BOARD OF WATER SUPPLY

Subject: Honolulu Board of Water Supply (BWS) Comments on the Red Hill
Administrative Order on Consent (AOC) Statement of Work (SOW)
Sections 6 and 7 Groundwater Modeling Working Group Meeting No. 8
Held February 12, 2018

Figure 1. A comparison of the simulated and measured groundwater elevations in the RHMNW. RHMW07 is excluded from this graph since the water level in this well is very anomalous. The Red Hill Shaft (2254-01) is also excluded due to questions about the top of casing reference

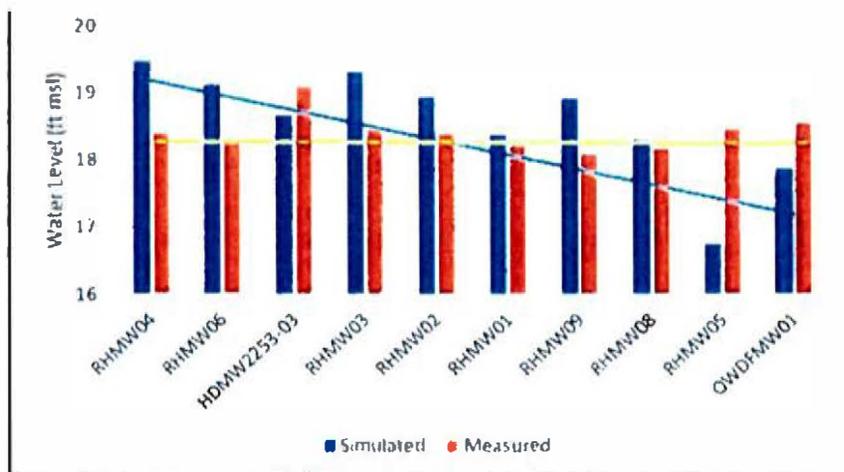
- The Navy's groundwater flow models should be calibrated to groundwater levels with the smallest possible tolerance limits because a difference of a few tenths of a foot in groundwater levels changes the rate and direction of groundwater flow and contaminant migration in the highly permeable basalt aquifer. Given this sensitivity, developing a sufficiently accurate groundwater model for the RHBFSF requires calibrating to measured water levels using as small of a tolerance limit as possible, such as the few tenths-of-a-foot error that are principally associated with groundwater level measurements. Instead, the Navy has created tolerance limits of a few feet by averaging multiple water levels taken during different pumping rates and recharge conditions and using the averages in the model calibration. The tolerance limits used by the Navy are large enough such that their model can be considered to be calibrated even though it predicts hydraulic gradients and groundwater flow directions that directly contradict the groundwater levels observed along Red Hill Ridge in 2015 and 2016. During this meeting, Mr. Robert Whittier of the Hawaii Department of Health (DOH) and the BWS asked the Navy's contractors how they could explain why the interim model's predicted flow direction at Red Hill contradicted the observed Red Hill groundwater levels. More recently, in his letter to Ms. Grange at the DOH dated February 20, 2018 (Whittier, 2018), Mr. Whittier showed how the interim model's predicted groundwater levels create a hydraulic gradient from monitoring well RHMW04 to monitoring well OWDFMW01 where none exists

(Figure 1, reproduced below from Mr. Whittier's letter). The observed groundwater gradient is shown by the yellow line whereas the interim model's inaccurate and contradictory gradient is shown by the blue line. Note that the differences between observed levels (red bars) and model predicted levels (blue bars) are typically between 1 and 2 feet.
